# Bowdens Mine Proposal: Surface Water Issues

IPC Public Hearing: 15 February 2023  
Shireen Baguley

Earth-Systems, 2022¶

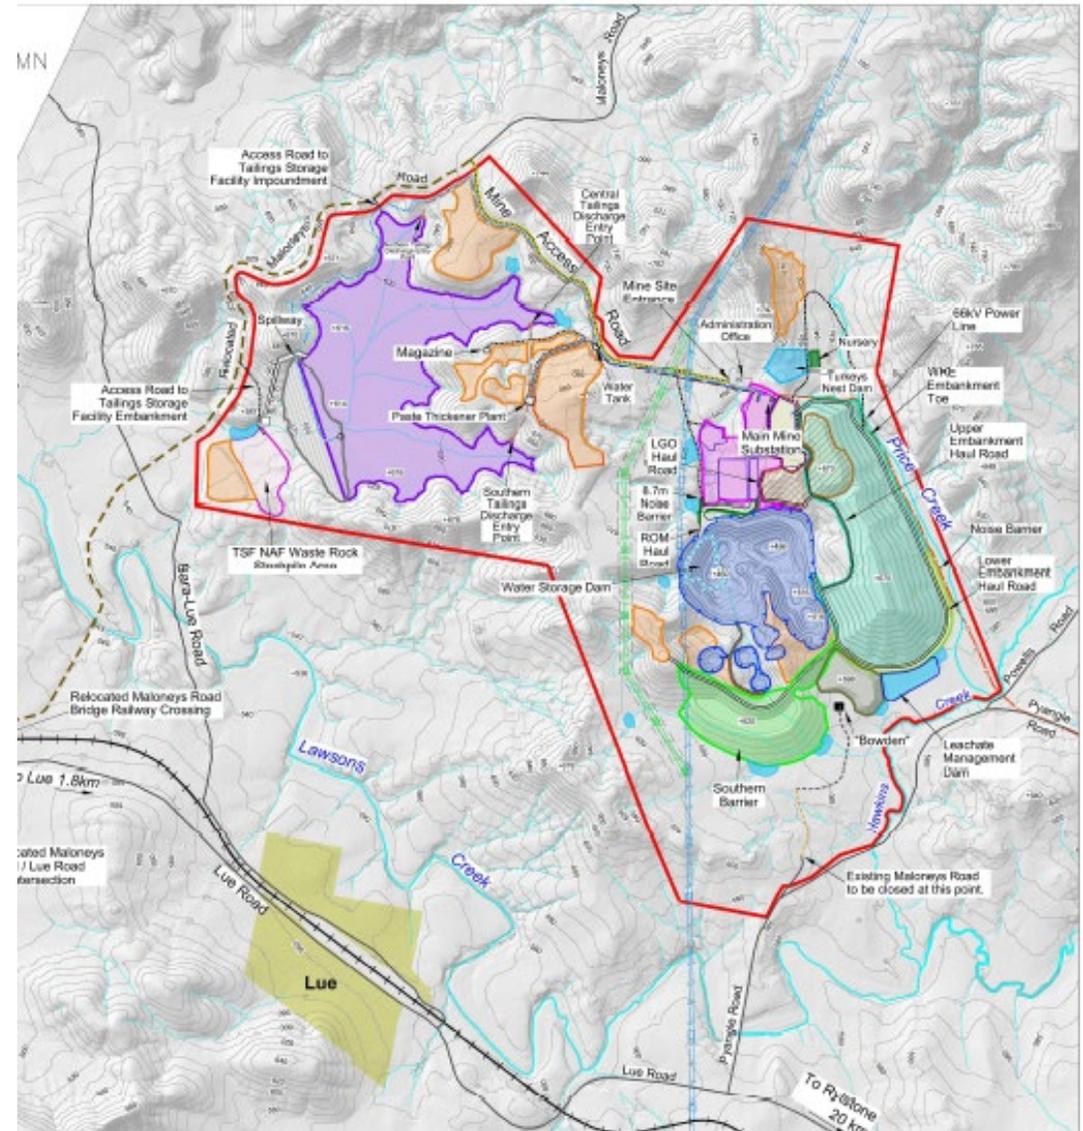
An assessment of potential water quality impacts associated with process chemicals has not been conducted, therefore it has not been possible to develop management measures. Impacts of TSF seepage on receiving surface water or groundwater remains a key concern.

Mine-site-area—Six-Maps—1007-Ha

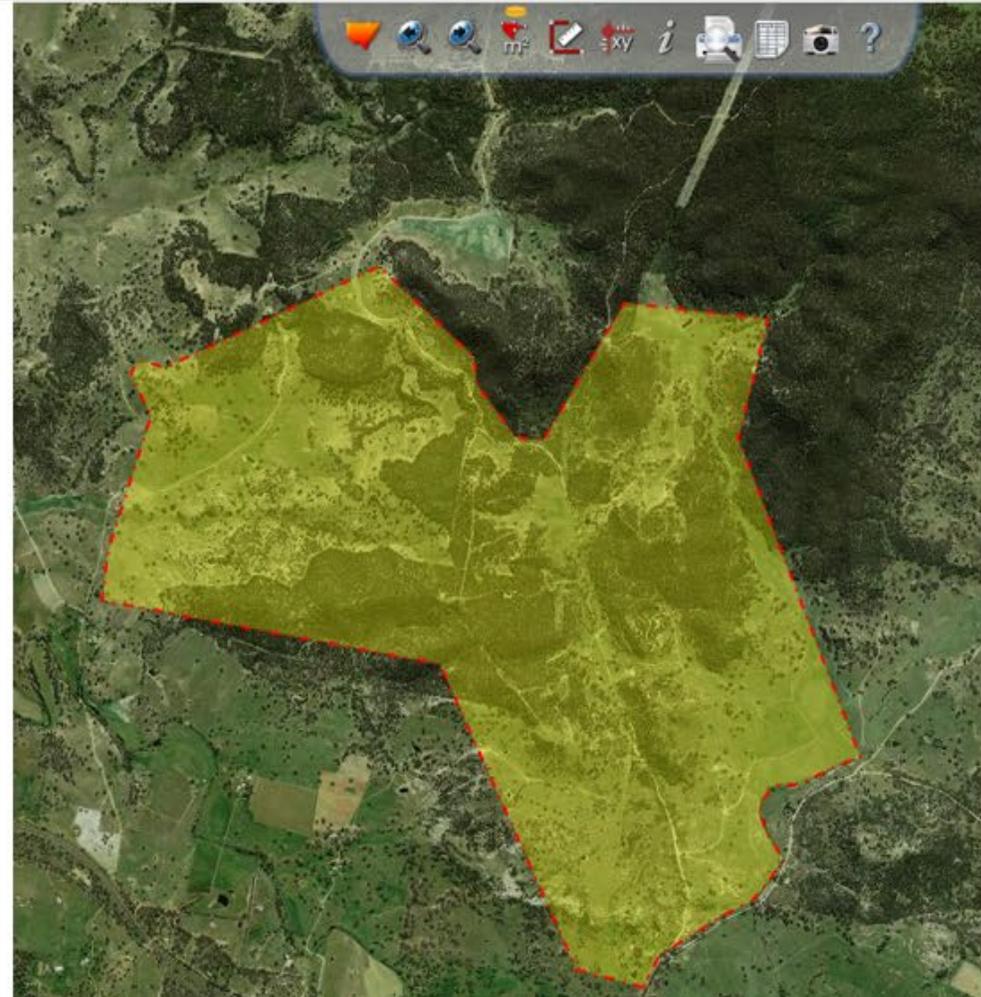
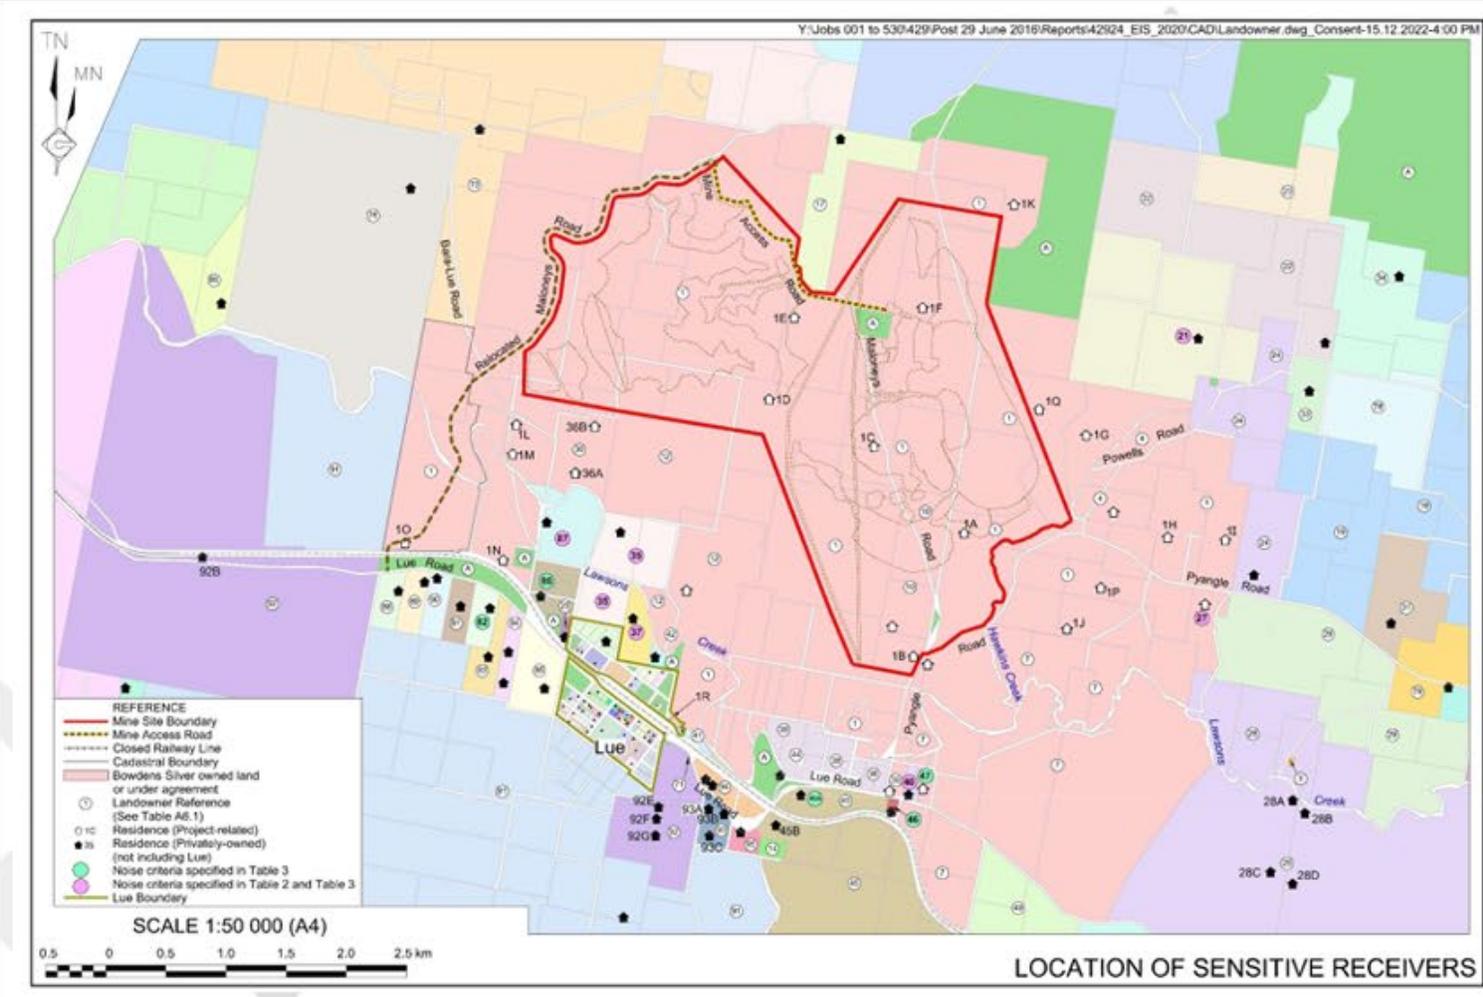
# Mine Site area unclear

550 ha Mine Site catchment

‘Removed’ in full to assessed the Project’s maximum impact on ‘cease to flow’ conditions

Proposed mining operations cover the majority of the Mine Site boundary (shown in red)

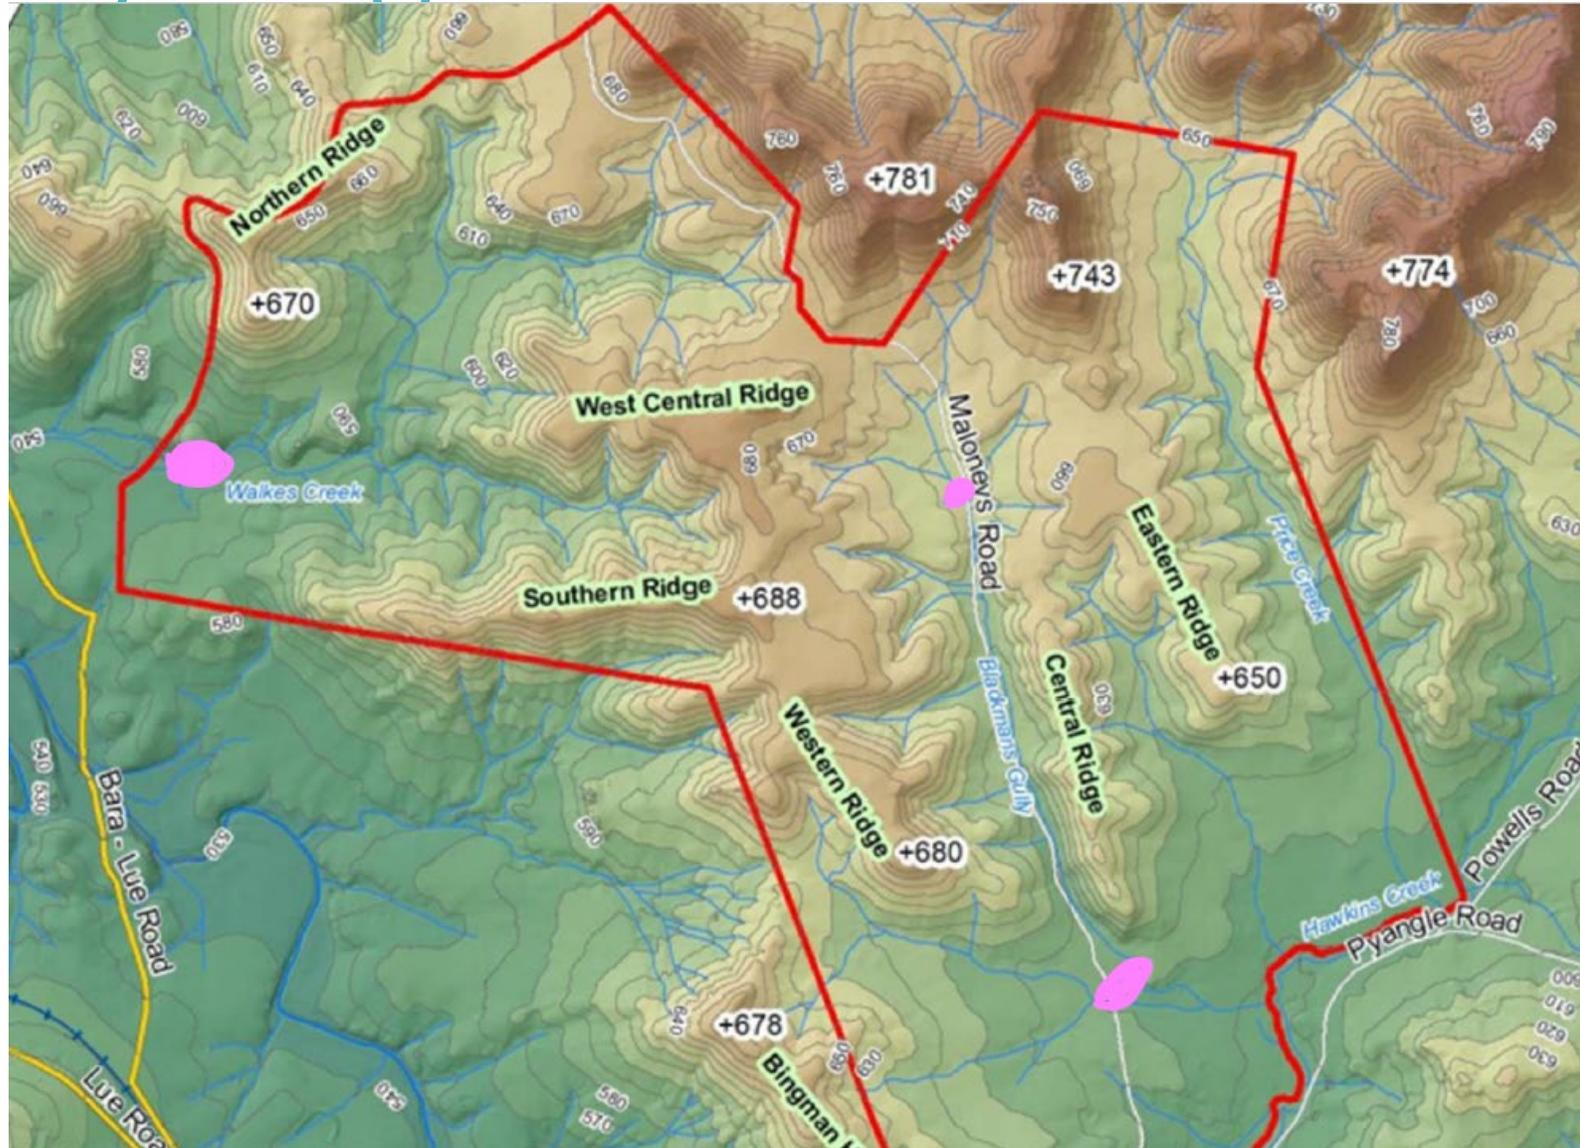
Context: Project relies on its harvestable water rights of 186.1ML – Permissible based on 2580 ha contiguous land holding

Volume of the sediment dams (150ML) and clean water dams (145ML) = **295ML**

Exceeds theoretical harvestable water rights **by 109ML**

186.1ML is the maximum volume of dams allowed, however already 59 dams across the 2580ha property. Assumed average of 1.5m = 72ML.

Remaining harvestable right of only **114ML**

**Bowdens intends to harvest more twice its entitlements**

Exemptions being relied on for these dams require these to be on minor streams

Violated in a number of instances: affects 70ML of the dam capacity
